**PLANNING & ZONING COMMISSION**  
**Regular Meeting**  
**Wednesday, March 18, 2015**  
**6:30 p.m.**

SUBJECT: Case 13-11 Birch Path Final PUD Plan/Plat Amendment

DATE: March 13, 2015

The applicant is requesting an amendment to the Final PUD Plan/Plat which includes reducing the subdivision from 19 lots to 17 lots. The reduction in the number of lots increases the lot widths and area of the remaining lots. With the proposed amendment, lot widths range up to 80' and lot area ranges from 6,091 sq. ft. to 14,347 sq. ft. Setback requests have remained unchanged.

BIRCH PATH P.U.D.  
127TH & I-355, LEMONT, IL  
EROSION CONTROL PLAN

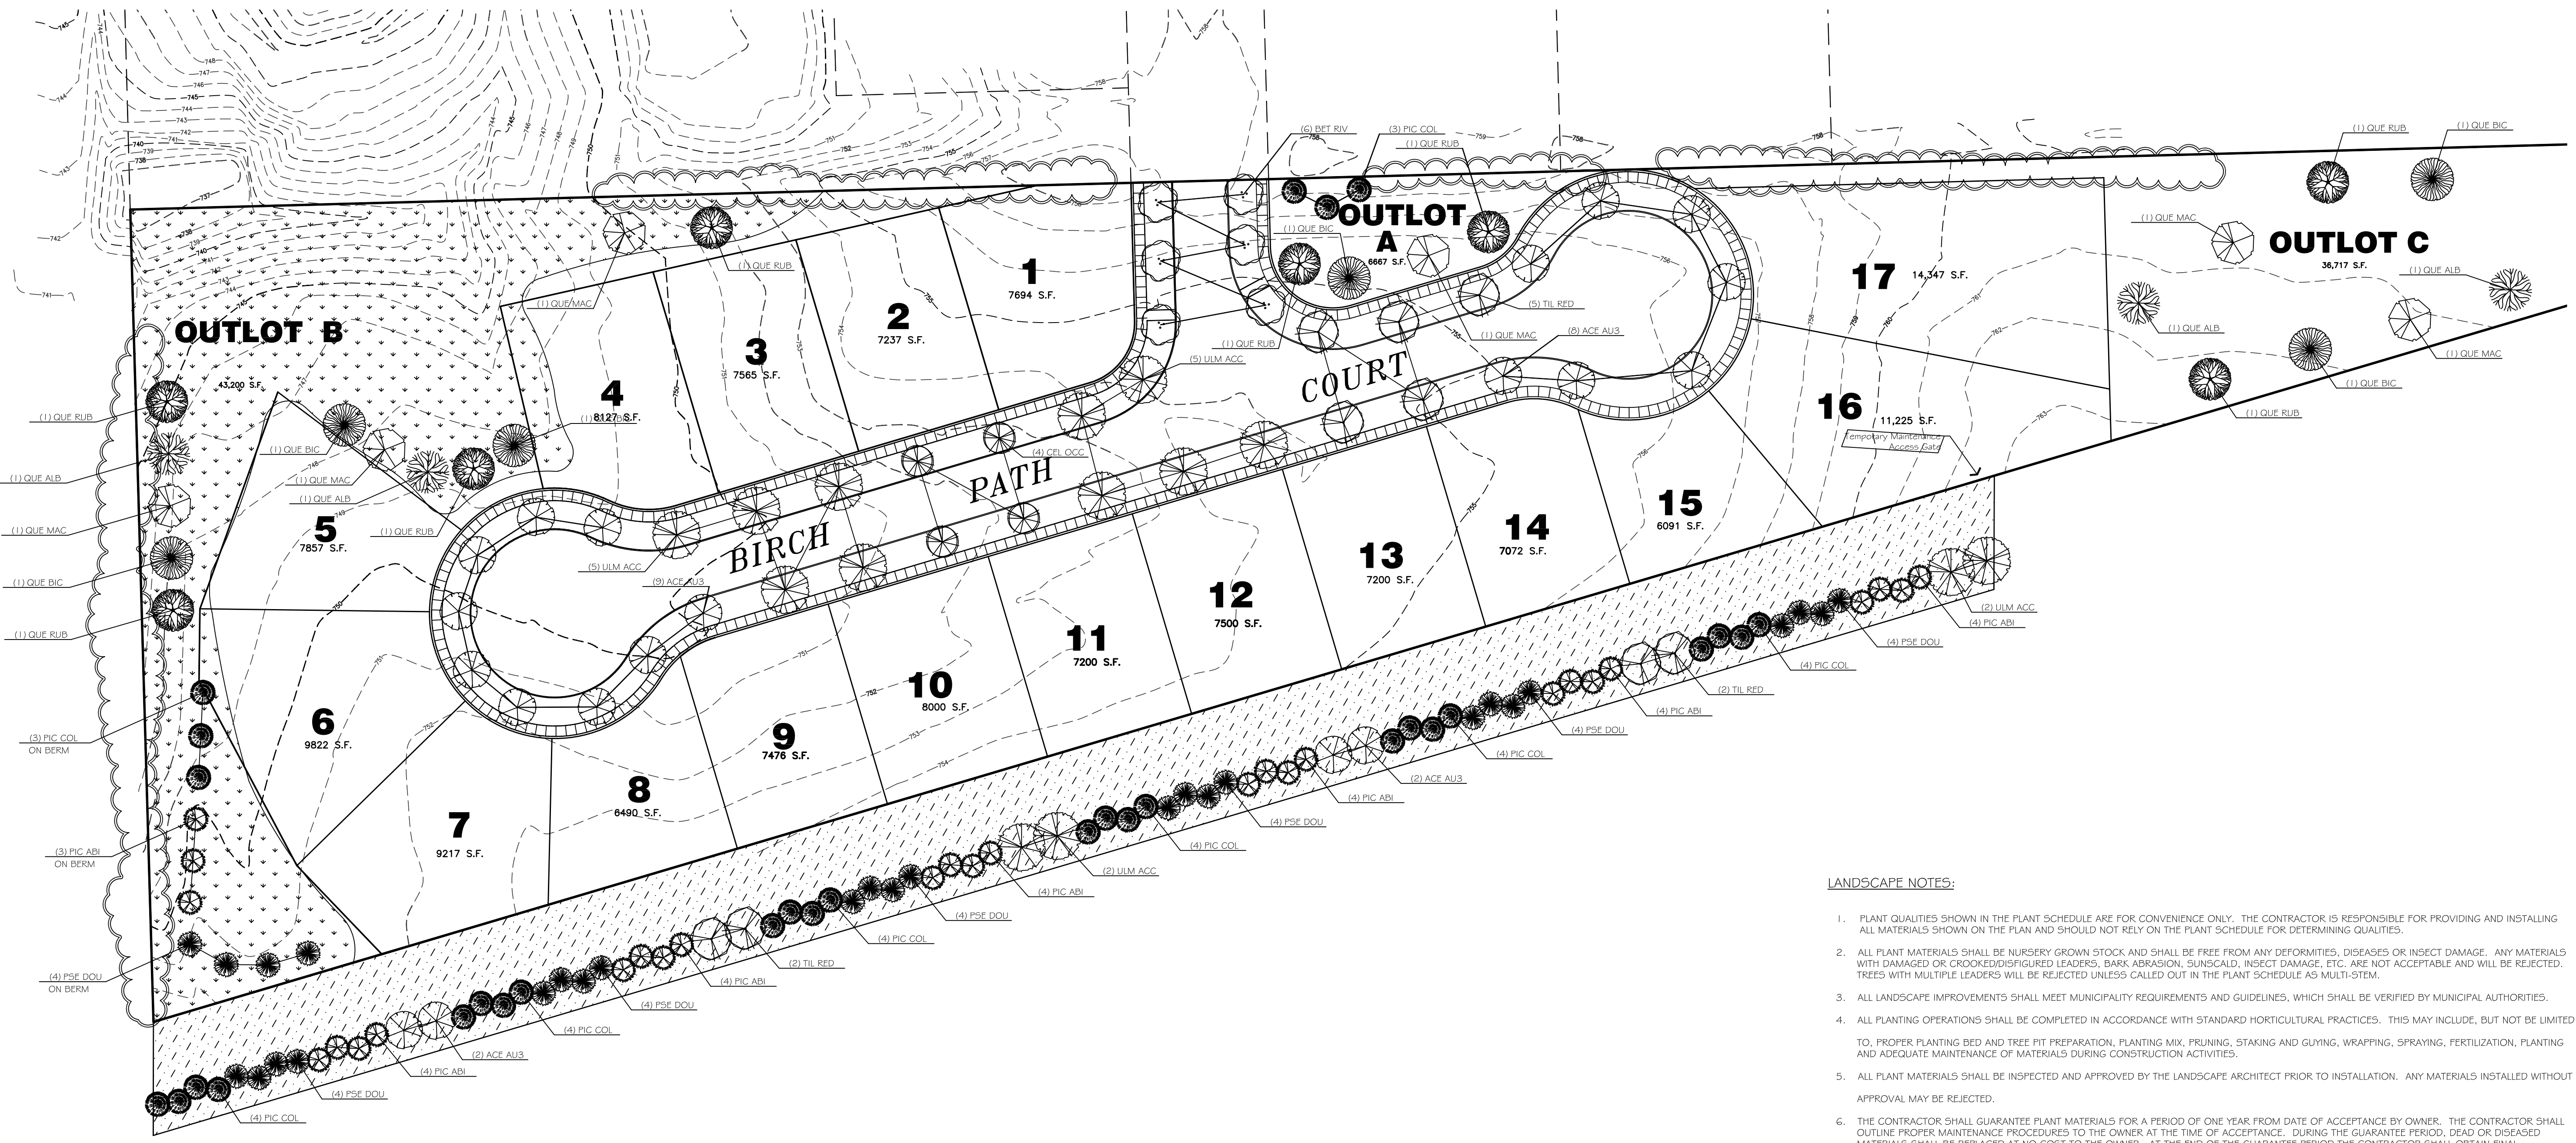
- 1) In the previously approved plans, the sidewalk around the western side of the northern cul-de-sac was shifted away from the eastern lot line in an effort to minimize the impact to the neighboring lot in Mayfair Estates. The sidewalk configuration should be reestablished as previously approved.
- 2) The note 1 on page 5 of 12 should be removed.
- 3) Note 27 on page 8 of 12 should be revised to read "Twenty-two (22) mitigation trees (6 swamp white oaks, 6 bur oaks, 6 red oaks and 4 white oaks) shall be planted in Outlots A, B & C as determined by Lemont's Arborist.
